REMARKS / ARGUMENTS

Appl. No. 10/731,496
Amdt. dated August 22, 2006
Reply to Office action of May 23, 2006

AMENDMENT TO THE DRAWINGS

Fig. 2

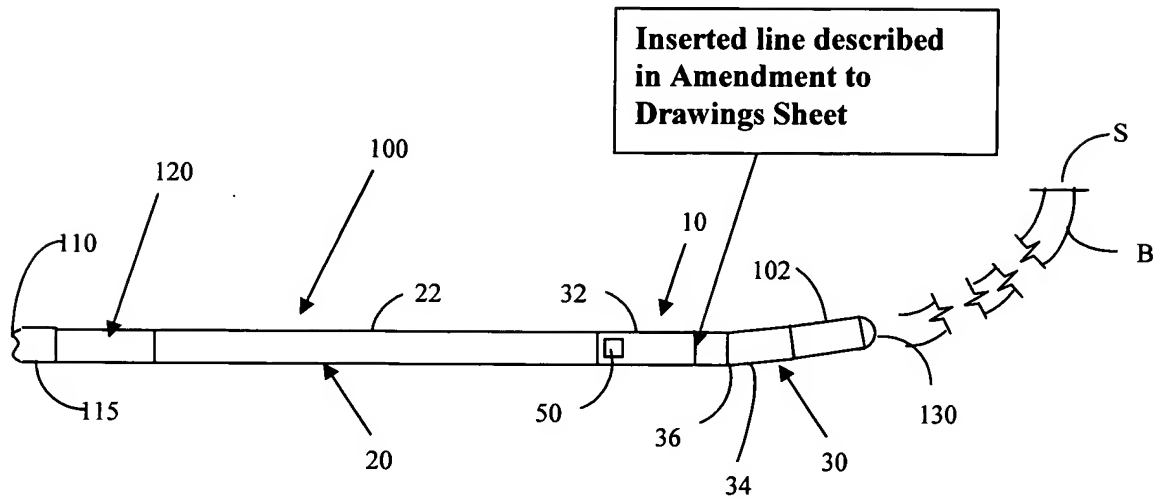
- Fig 2
 - Line was missing in drawing adjacent to Item 36. Line has been inserted so as to
 - clearly identify the division between Items 32 and 34
- Fig 3.
 - Line as missing in drawing adjacent to Item 36. Line has been inserted so as to
 - clearly identify the division between Items 32 and 34
- Fig 4.
 - Numerical call out for Item 24 was moved to provide clarity
 - Item 32 was identifying the wrong item and has been corrected to illustrate the appropriate component
